ADDENDUM 01

QUESTIONS RECEIVED RE BARTOW COUNTY GA FLAP GRANT RESURFACING PROJECT

DETAIL FOR PAVING TURNOUTS FOR SIDE ROADS, STREETS, AND DRIVES

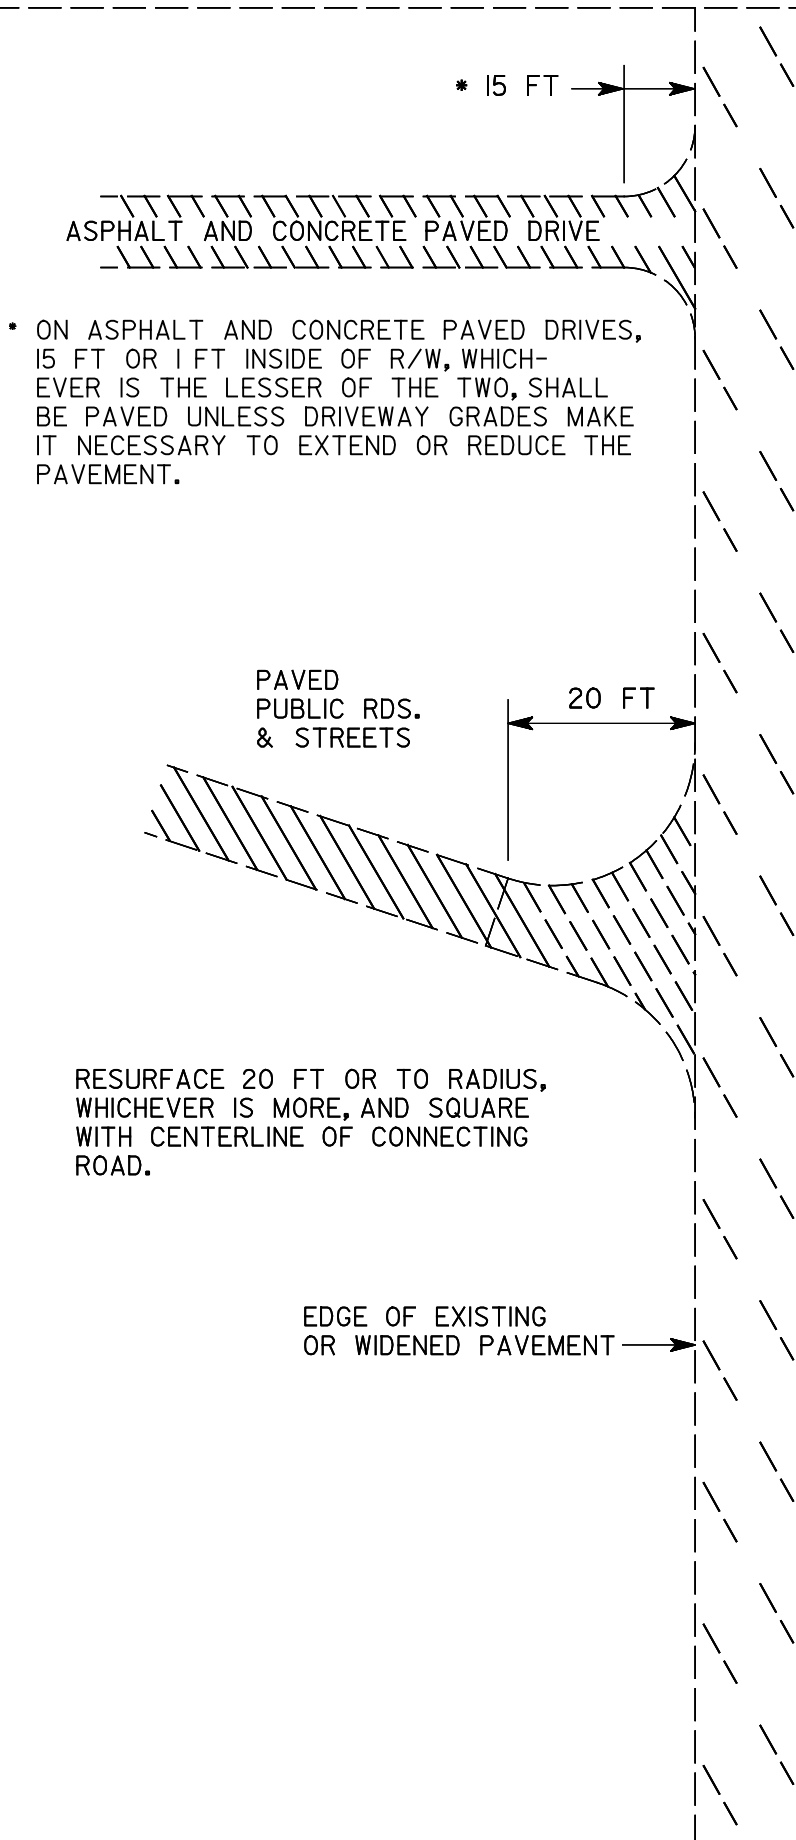
- How far back into adjacent Side Roads will the Contractor need to plan on paving for tie ins? Typically GDOT will provide a Construction Detail for this.

- How far back into adjacent Driveways will the Contractor need to plan on paving for tie ins? Typically GDOT will provide a Construction Detail for this.

The driveway and intersecting road pavement detail has been added to the plans. See attached.
